Your ref:  
Our ref: LTR-NRC-02-60

Subject: Response to RAI on the "Topical Report on Modular Accident Analysis Program Version 5 (MAAP5) Pressurized Water Reactor (PWR) Large Dry Containment Model," WCAP-15844

## 2.0 MAAP5 Topical Report

Figure 1: Calculated velocities in node 2 for steam discharge into node 2 and also for equal discharges into nodes 2 and 6.

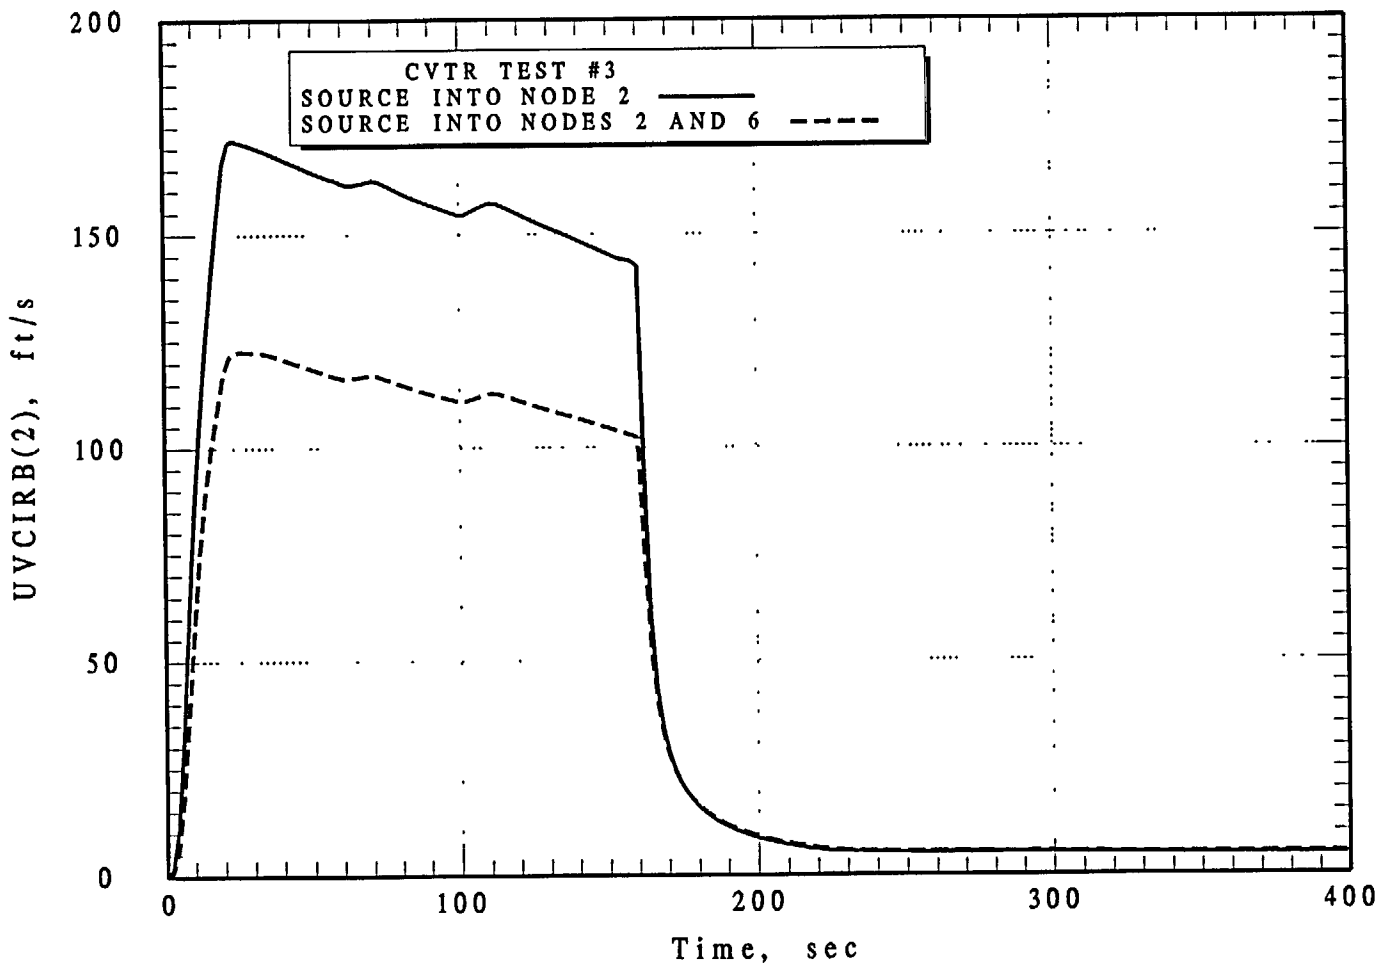
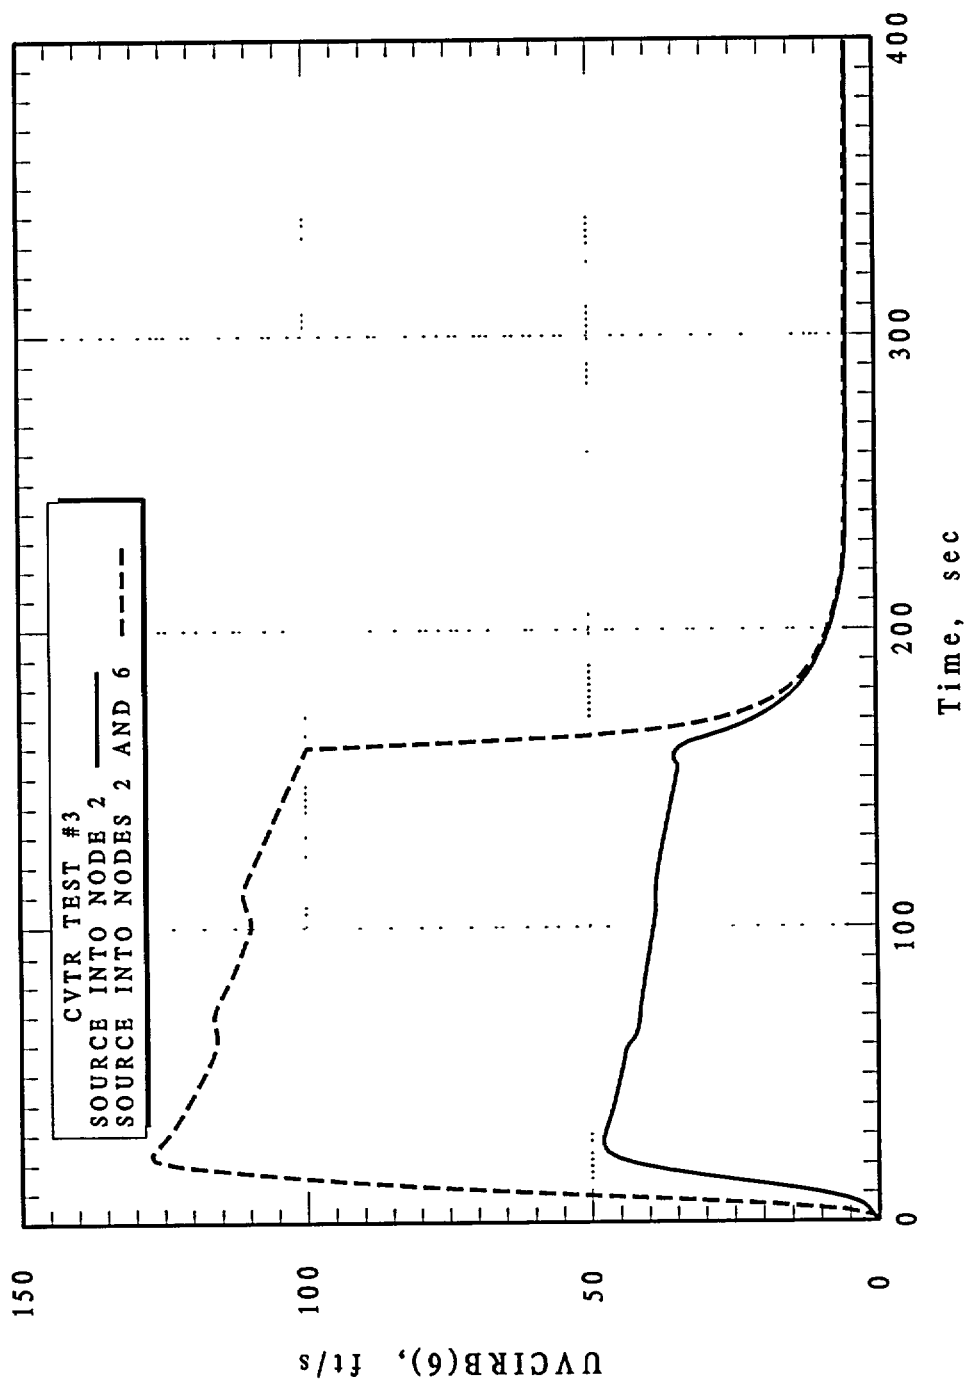
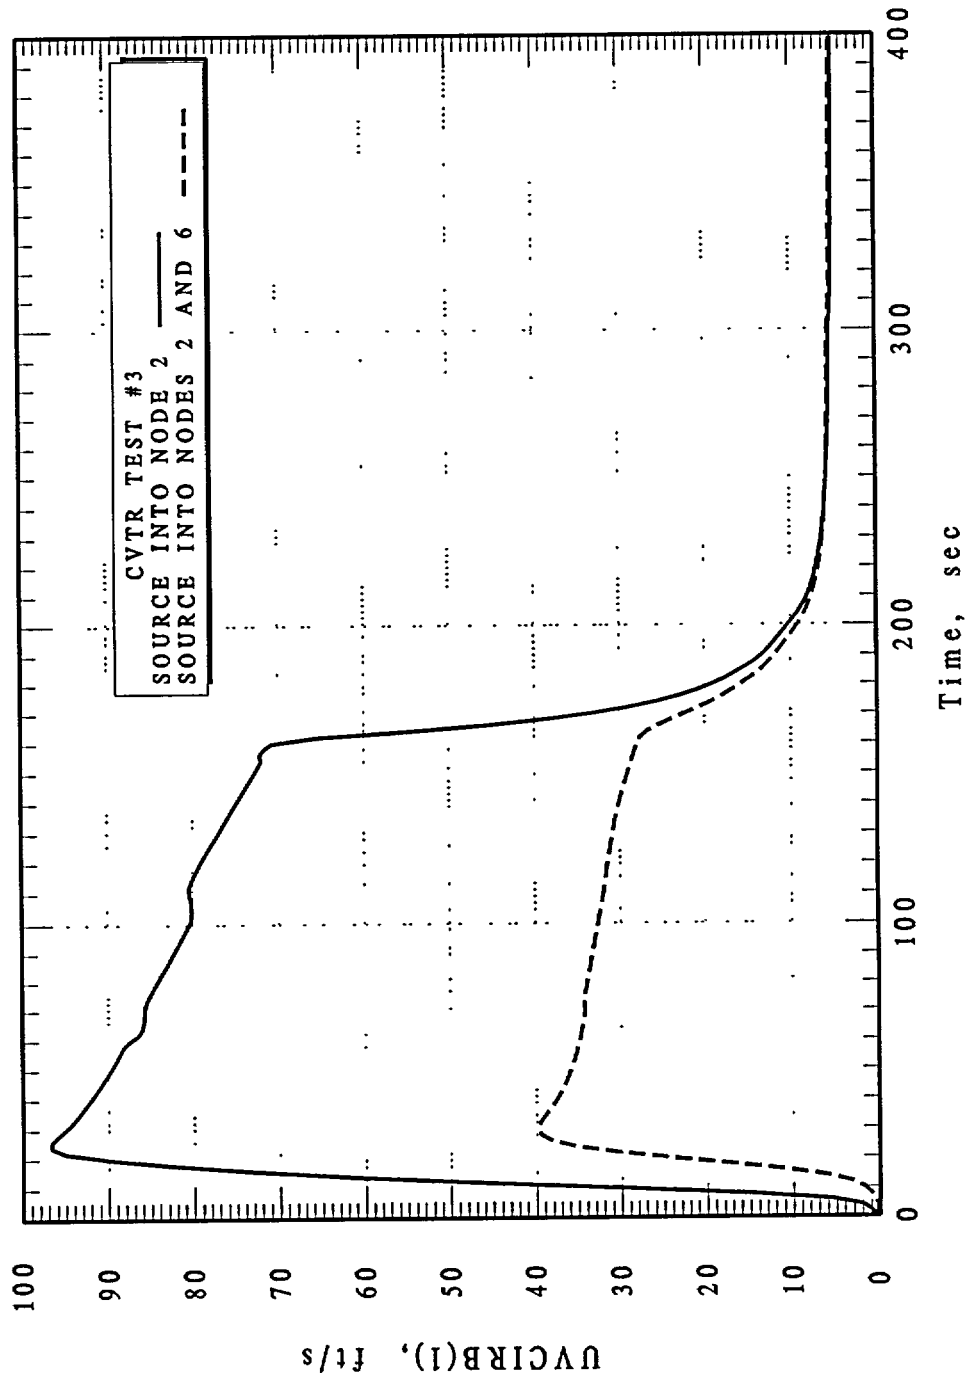
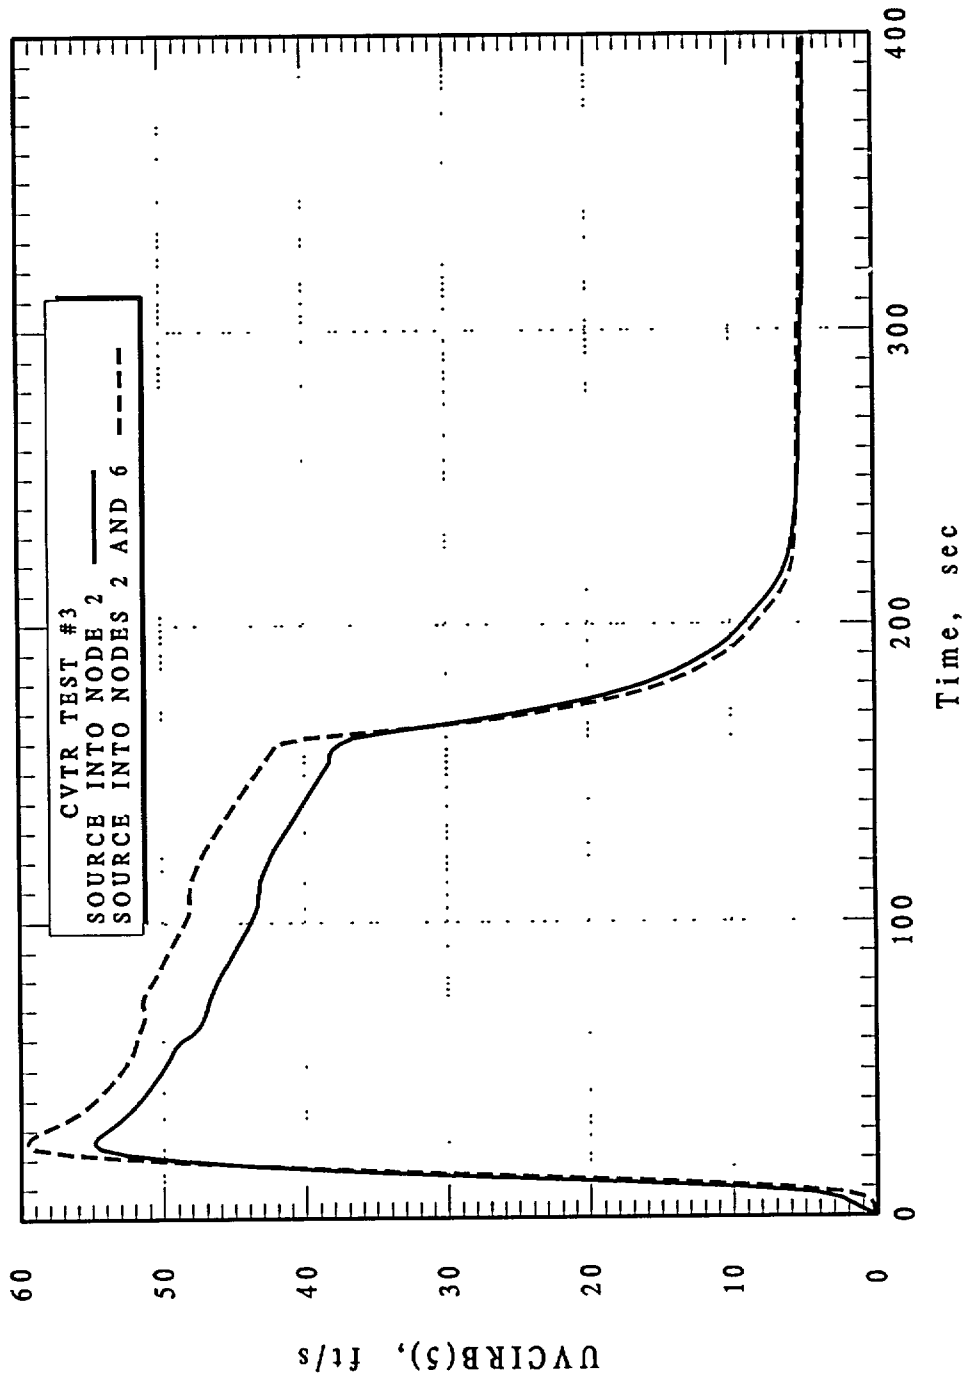
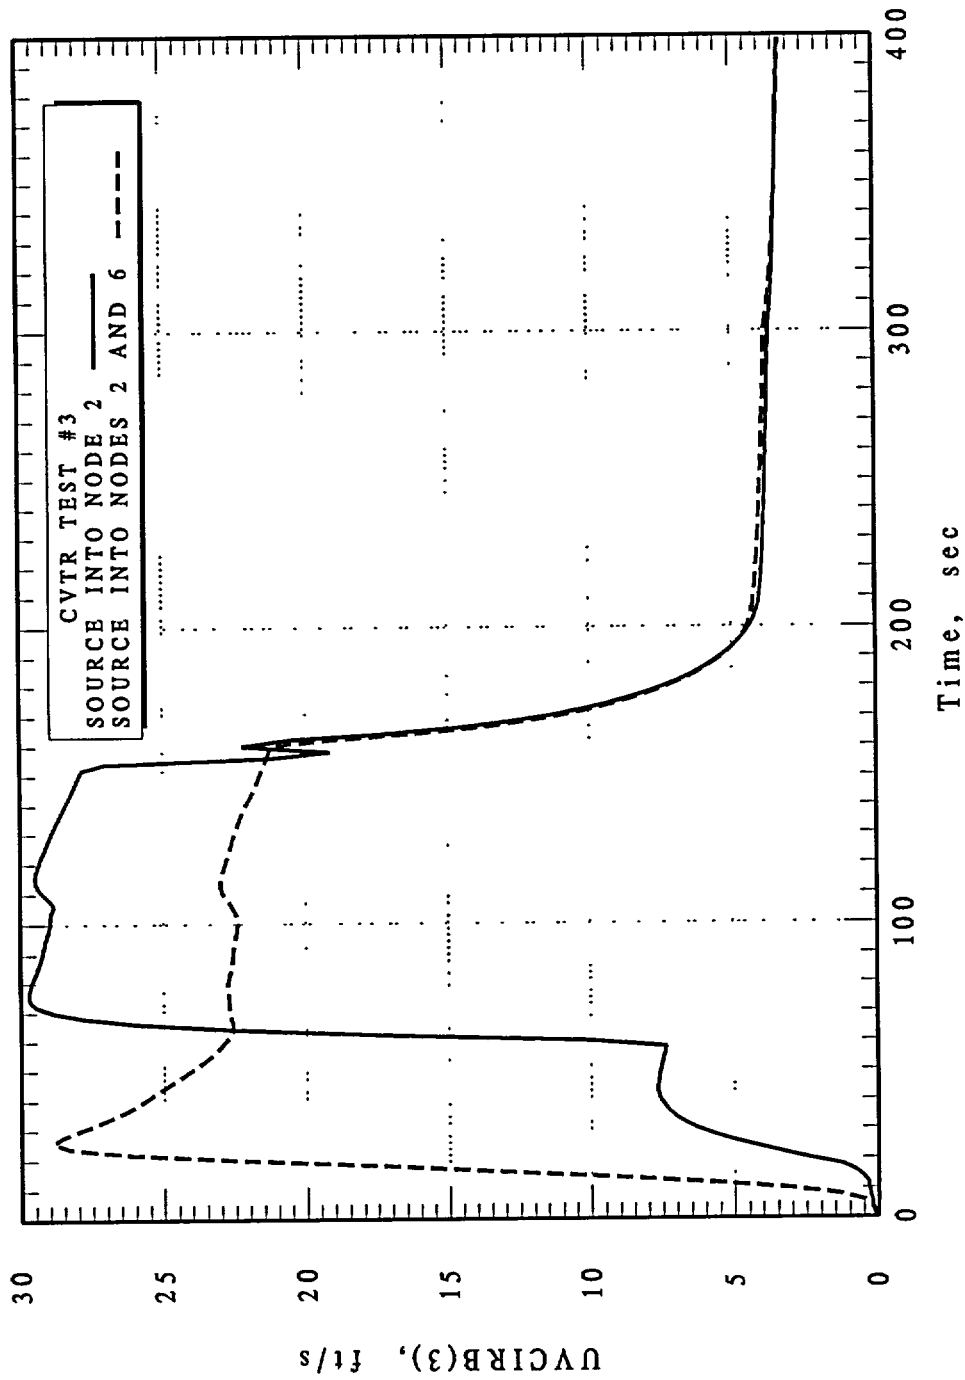
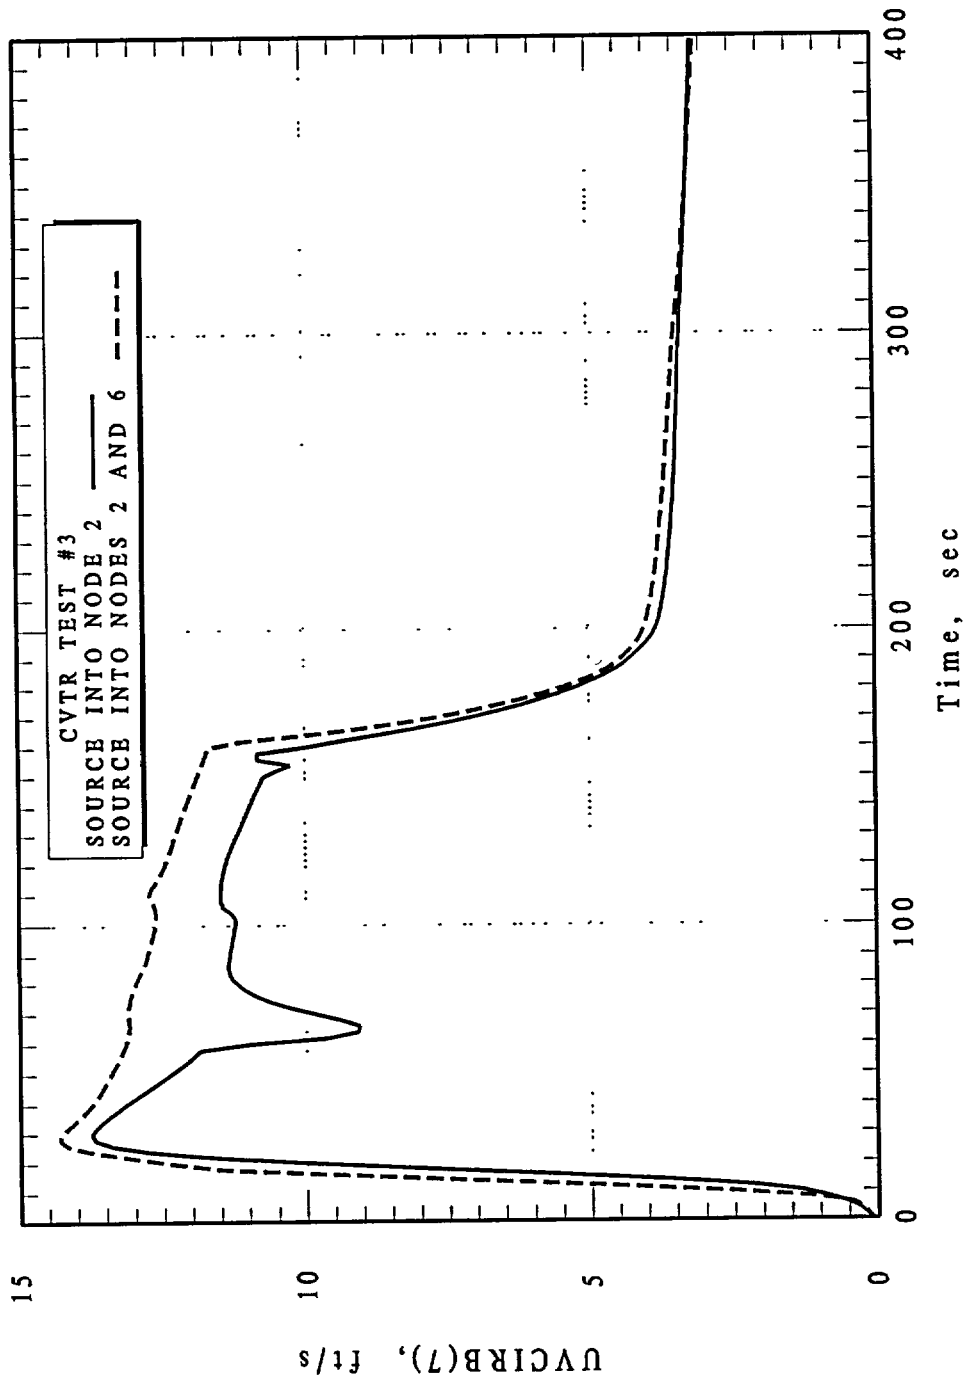
**Item 2.2.9. It appears that FAI is using the CVTR test#3 measured velocity as a partial validation of the □momentum-driven velocity□ model. However, measurements (both direct and indirect), as well as published CFD calculations for test #3, all indicate that the peak wall velocity is 5-6 times lower than calculated using MAAP. Further, the annular gap velocity calculated by MAAP is approximately twice the value reported in the CVTR final report. Please comment. What additional, direct validation of calculated momentum-driven velocity has been obtained (other than CVTR) through the 5SSTAR process?**

As described in the CVTR experimental report, steam was introduced above the operating deck through a 10 inch diffuser pipe (numerous small holes) to discharge the steam in several directions. In the MAAP5 Topical Report CVTR has been analyzed assuming that the steam was discharged into a single node above the operating deck (node 2 of the 12 node MAAP5 containment model). Additionally, for the RAI responses the containment response has been analyzed assuming that the steam was discharged equally into nodes 2 and 6 (both nodes are immediately above the operating deck).

The MAAP5 calculated momentum driven velocities are illustrated for nodes 1, 2, 3 and 4 for the two different M&E assumptions. As illustrated in Figures 1 through 6, when the source is discharged only into node #2, that node and node #1 immediately have velocities significantly higher than those indicated by the ultrasonic anemometer in the annular gap (15 ft/sec) and near the bend line (30 ft/sec). When the mass and energy is assumed to be distributed between nodes 2 and 6, the velocity in the break nodes are approximately 3 times the reported velocity. However, those velocities in the nodes immediately above the break node(s), show velocities comparable to those in the CVTR experimental report. Also, it is to be noted that when the steam is injected only into node #2, the calculated velocity in node #6 is also comparable to that in the CVTR report. The results for nodes #3 and #7, which are immediately below the operating deck show calculated velocities comparable to those reported in the annular gap.

In summary, as anticipated, there are a spectrum of velocities calculated with those in the break node(s) being the maximum. However, velocities in the other nodes result in calculated values which are comparable to those given in the CVTR data report.

Figure 1: Comparison of CVTR response for the M&E released into a single node or into adjacent nodes along with the experimentally measured pressures.

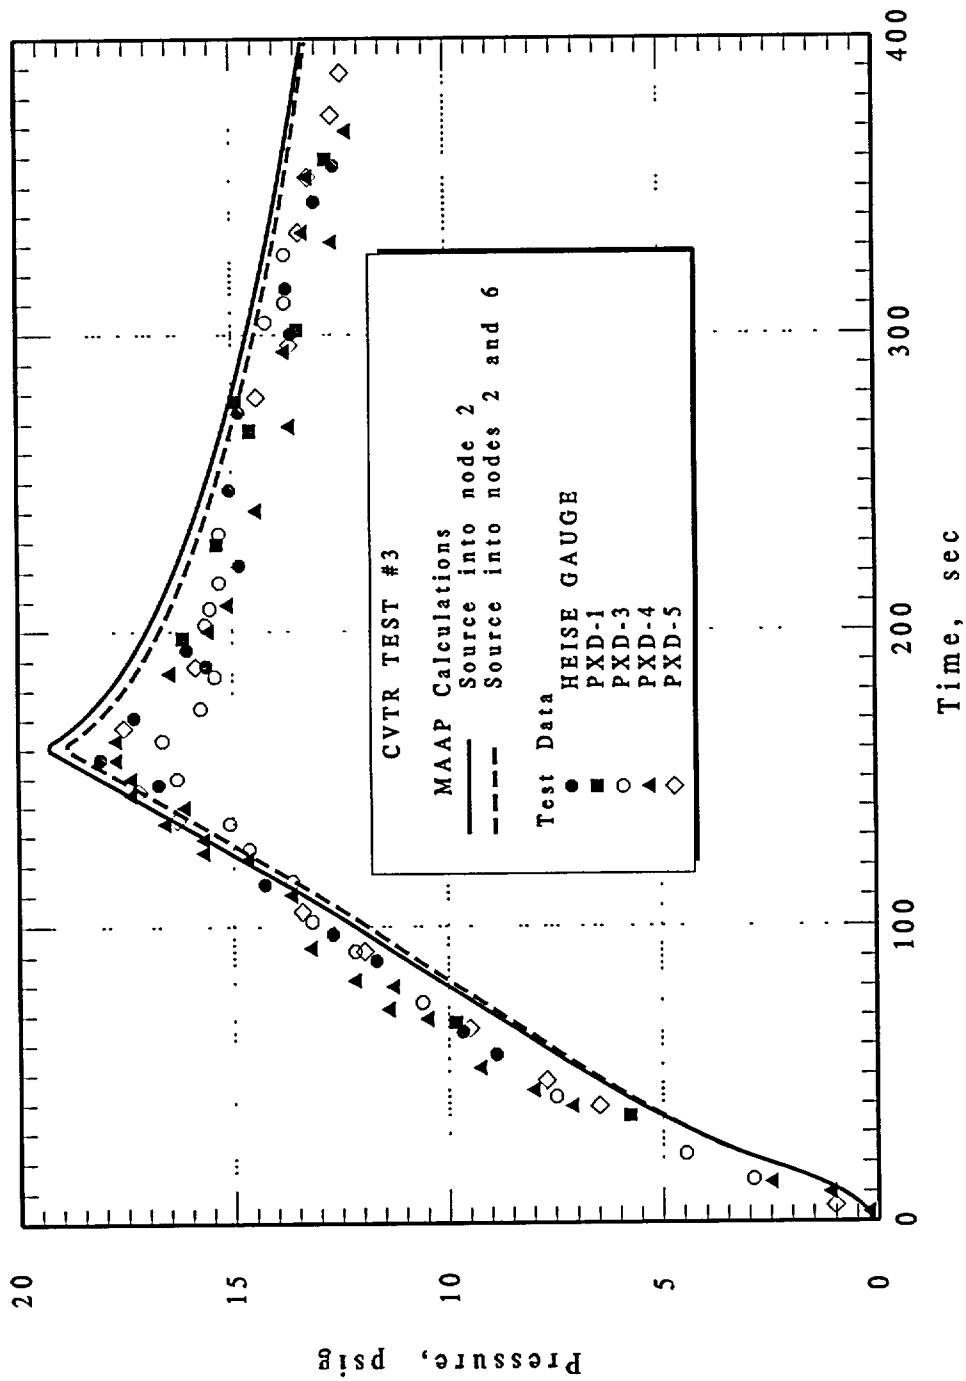
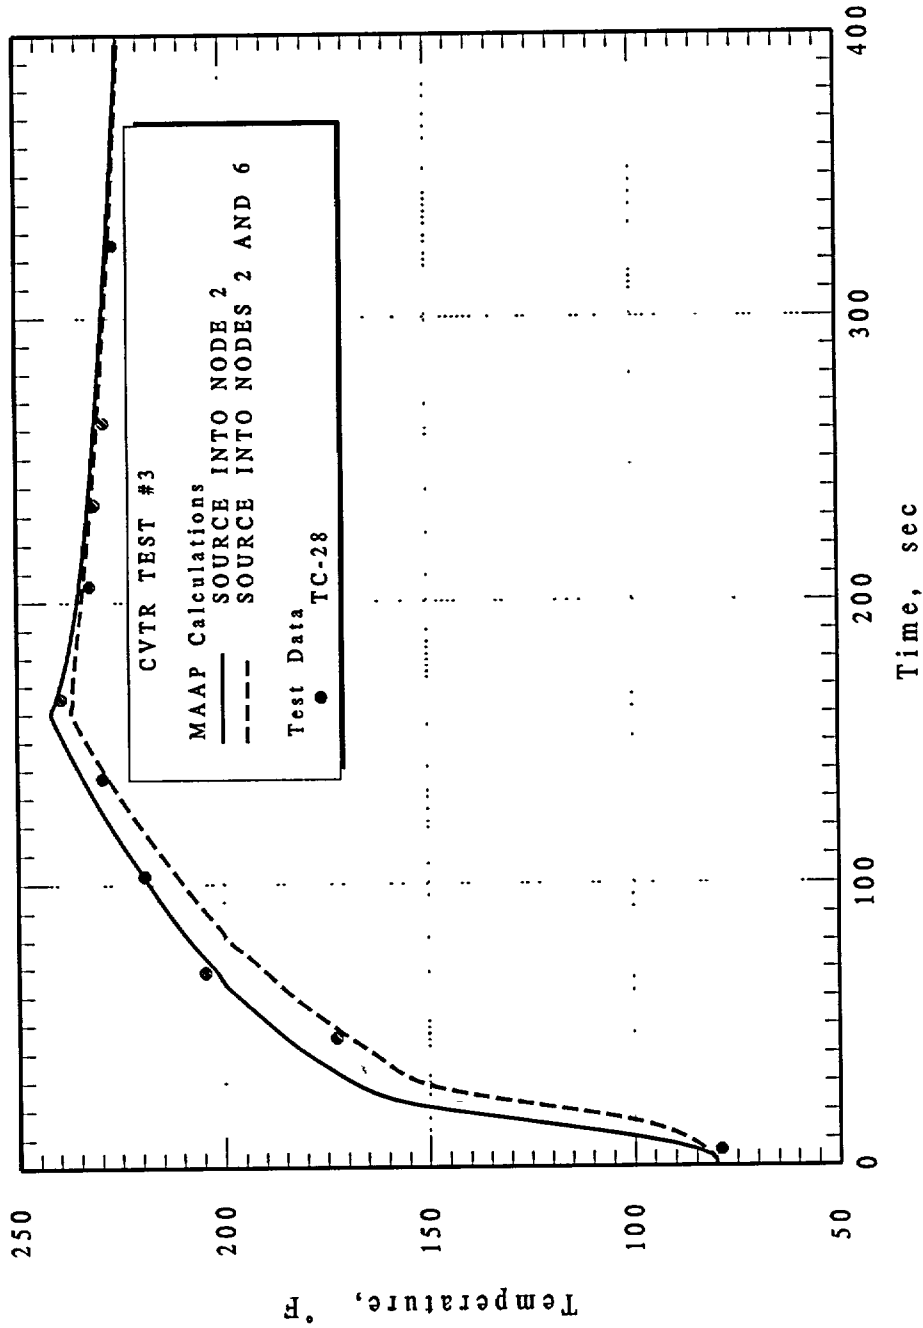
**Item 2.2.10. Provide a comparison of CVTR heat plug #2 heat transfer coefficients calculated for the MAAP uncertainty parameters.**

As described in the experimental report, steam was introduced above the operating deck through a 10 inch diffuser pipe (numerous small holes) to discharge the steam in several directions. CVTR has been analyzed assuming that the steam was discharged into a single node above the operating deck (node 2 of the 12 node MAAP5 containment model). Additionally, the response has been analyzed assuming that the steam was discharged equally into nodes 2 and 6 (both nodes are immediately above the operating deck). Figure 1 shows the containment pressure responses using these two assumptions with the associated temperature responses being shown in Figure 2. Only small differences are calculated in the global response of the containment peak pressure and temperature.
